ADDENDUM NO. 02
To Drawings and Specifications dated 02/07/24

Date: FEBRUARY 7, 2024

PROJECT: **Warner Middle School HVAC Upgrade & Modernization**
A#04-121954
Westminster School District

25 DEMO RCP BUILDING IA1
1/8" = 1'-0"

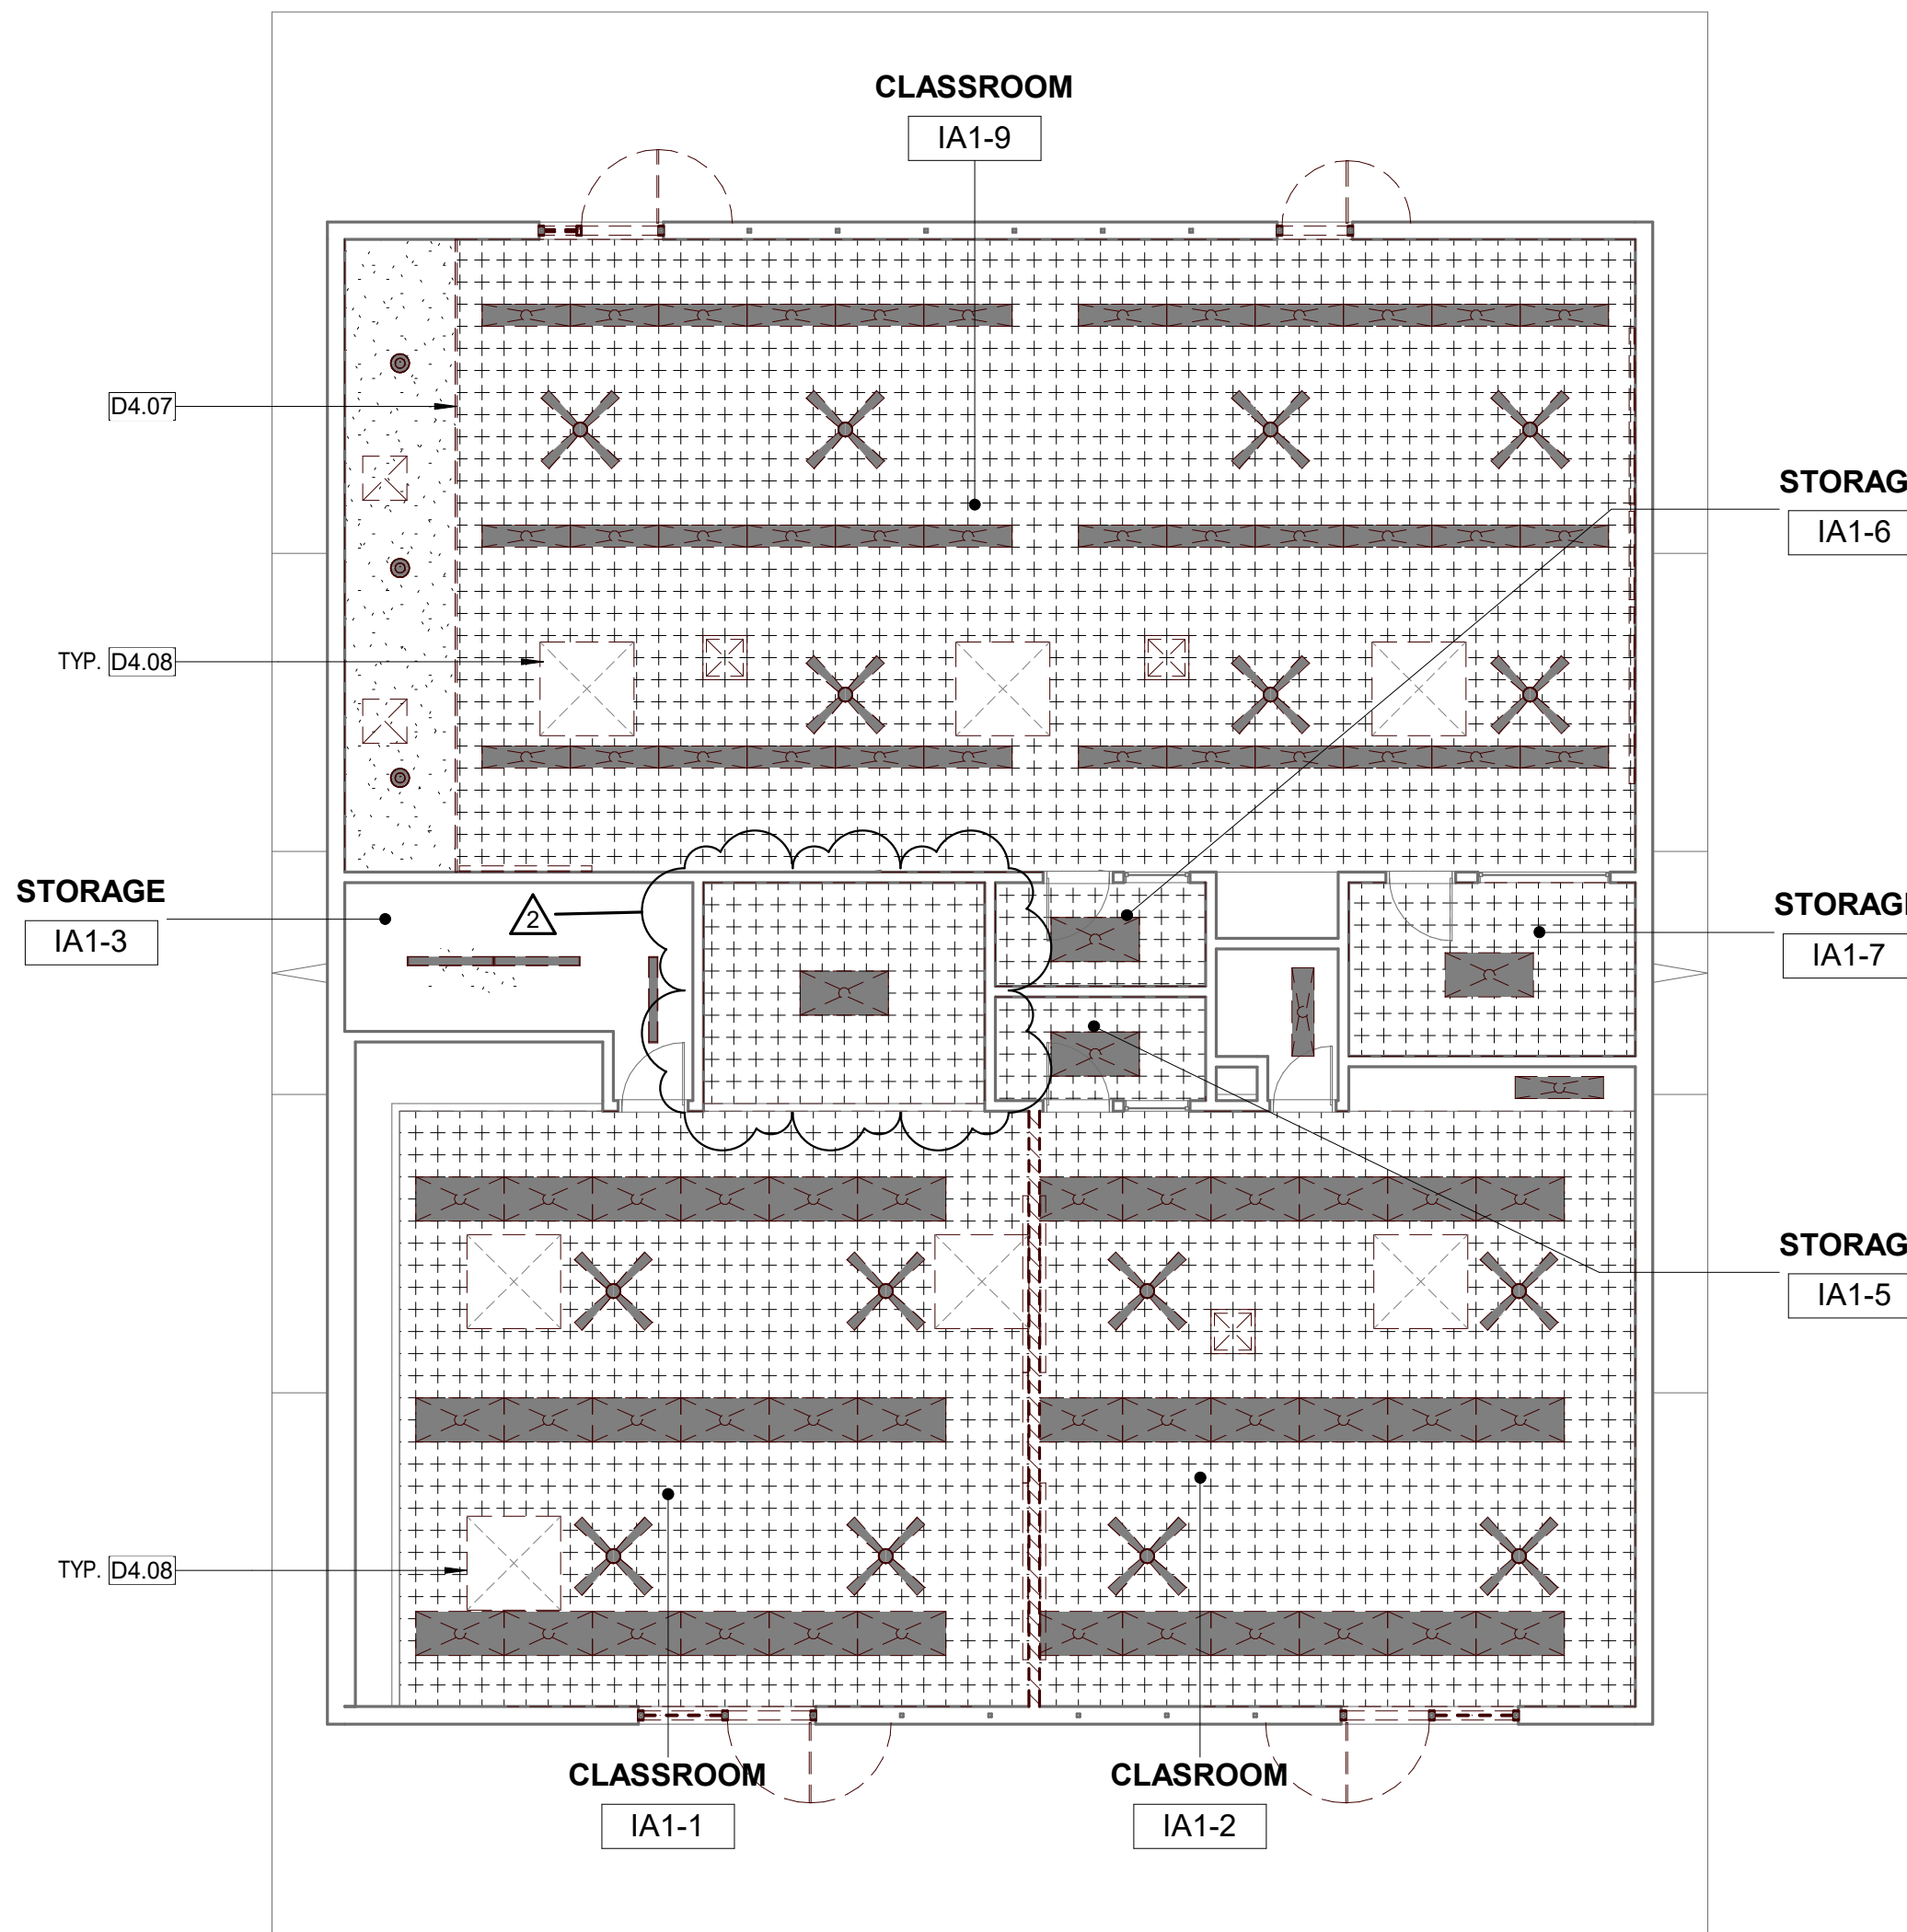
1. Detail "25 – Demo RCP Building IA1"
 - a. Revised Demo RCP.

18D CLASSROOM IA1-9 - WEST ELEVATION
1/4" = 1'-0"

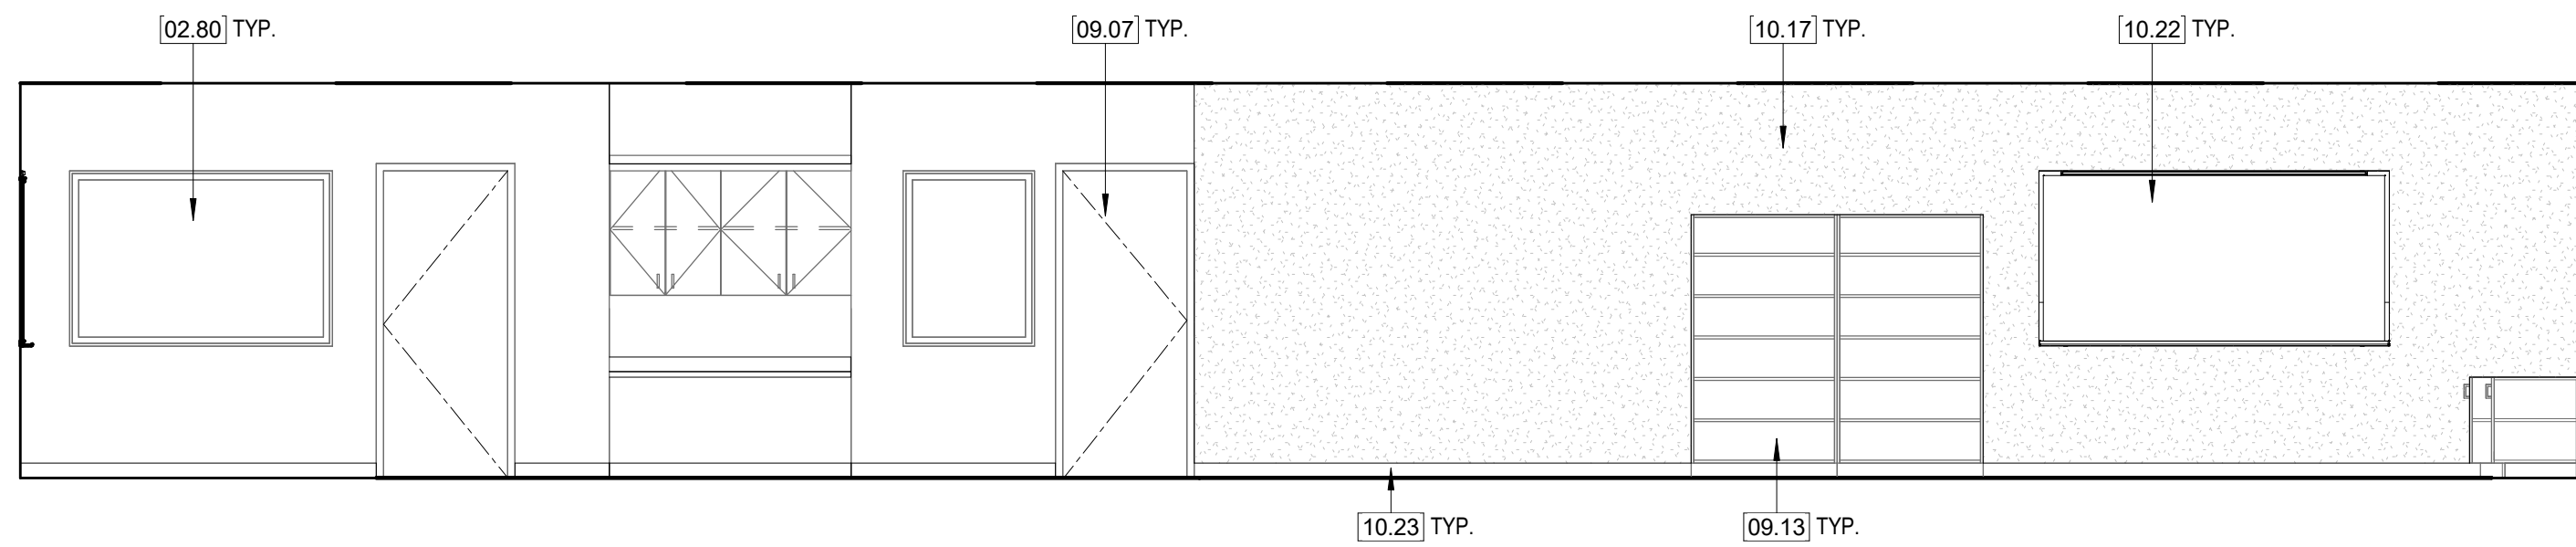
1. Detail "18D – Classroom IA1-9 – West Elevation"
 - a. Added note "Removed and reinstalled (E) power & (E) data after tackboard reinstallation. Typ."

18D INTERIOR ELEVATION - IA2-2 - WEST

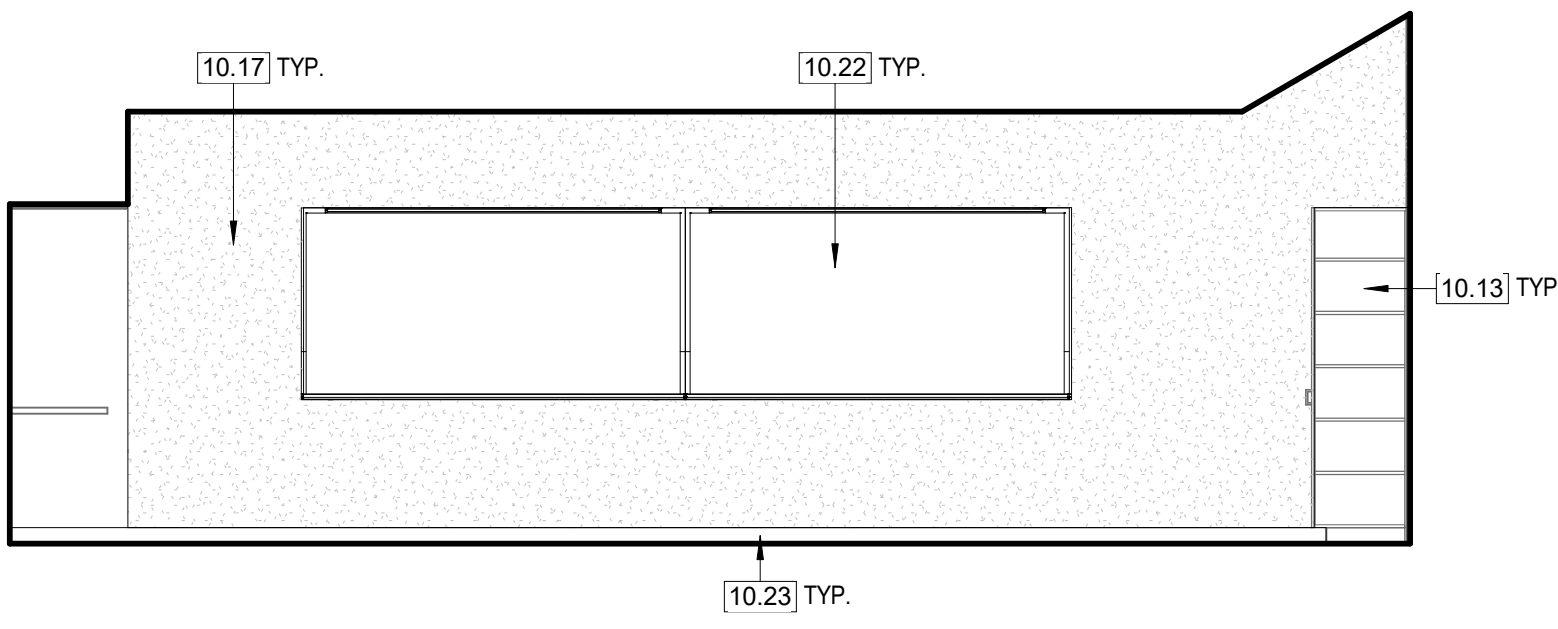
1. Detail "6B – Interior Elevation – IA2-1 – East"
 - a. Added note "Removed and reinstalled (E) power & (E) data after tackboard reinstallation. Typ."
2. Detail "18D – Interior Elevation – IA2-2 – West"
 - a. Added note "Removed and reinstalled (E) power & (E) data after tackboard reinstallation. Typ."

29 FLOOR PLAN - BUILDING C1
3/32" = 1'-0"

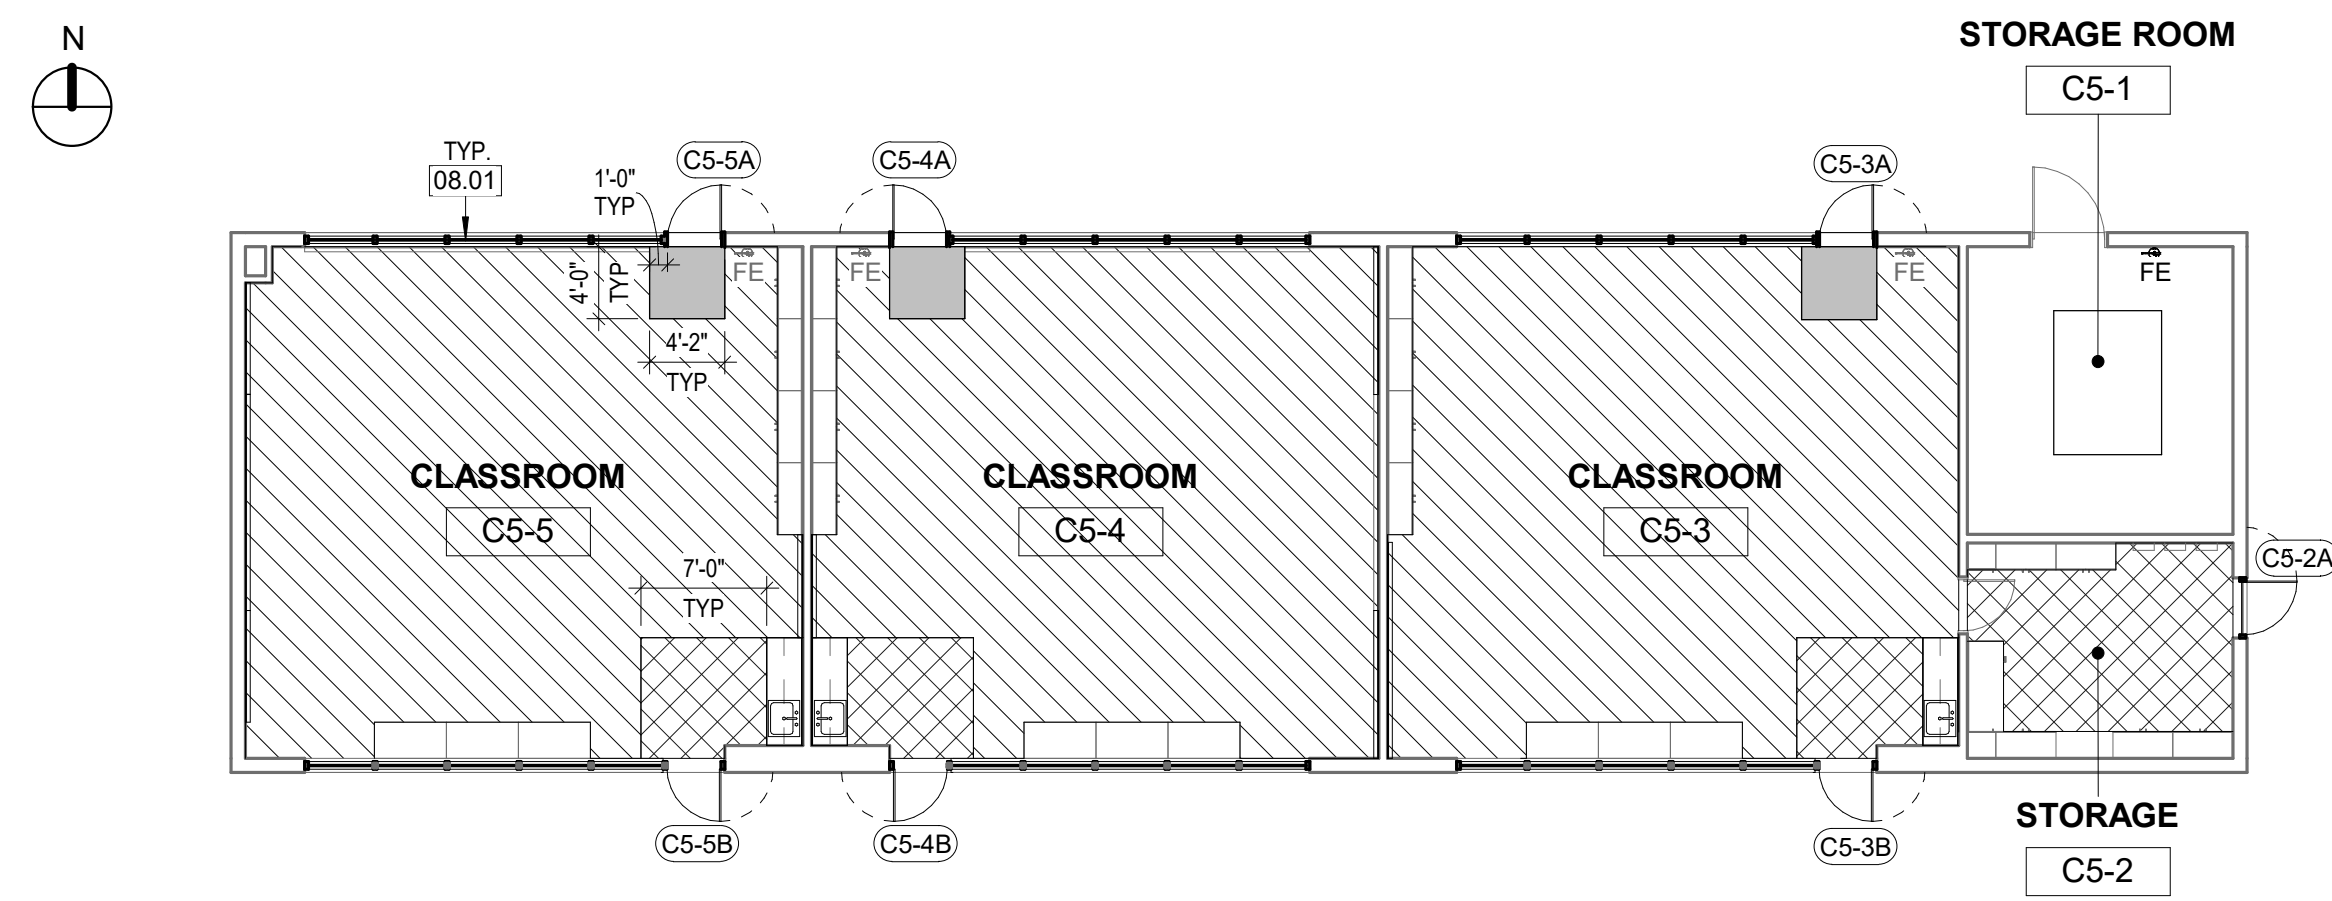
12. Detail "29 – Floor Plan – BUILDING C1"
 - a. Added "LVT" to classroom C1-3, C1-4 & C1-5.
